REPOSITORY SITE

Task 2 - Criteria Development

Volume II - First Draft

February, 1979

FIGURE III - 3
SCHEMATIC DRAWING OF APPLICATION OF
LIMITING CRITERIA FOR VOLCANIC EFFECTS

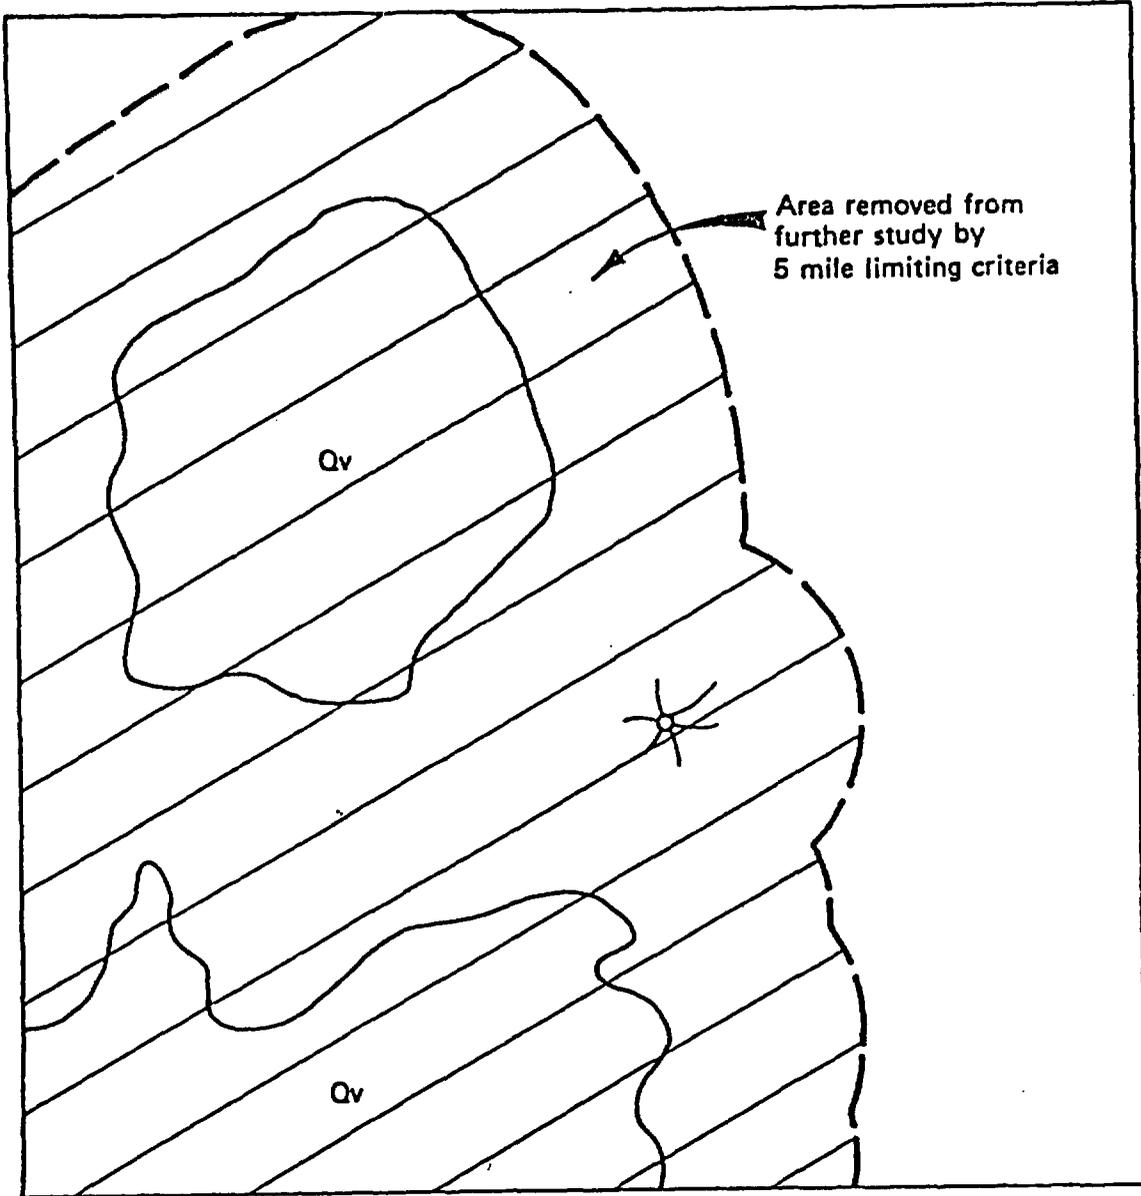
Prevaling wind direction?

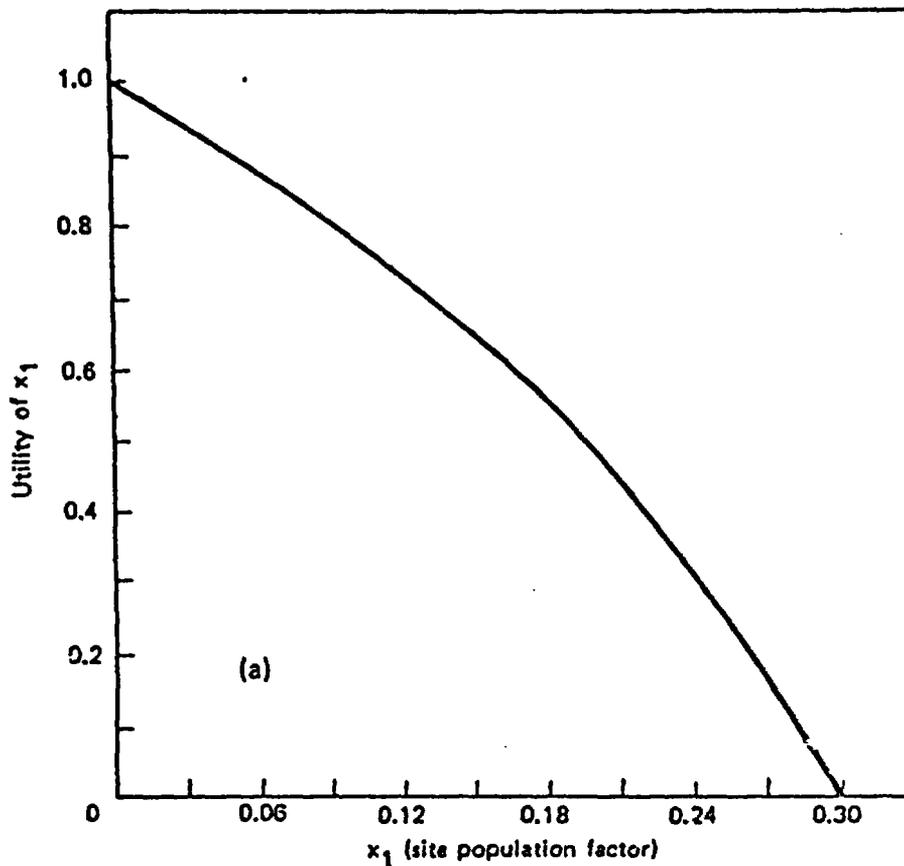
needs sub-healthy
+ not off
very important
uncertainty!

FIGURE III - 5

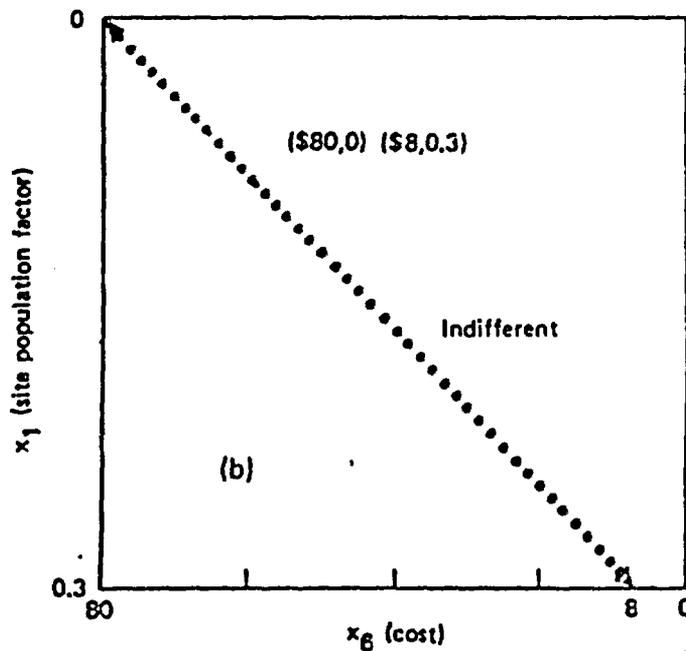
might want to show utility curve for cost and also say some words about differential cost within total cost.
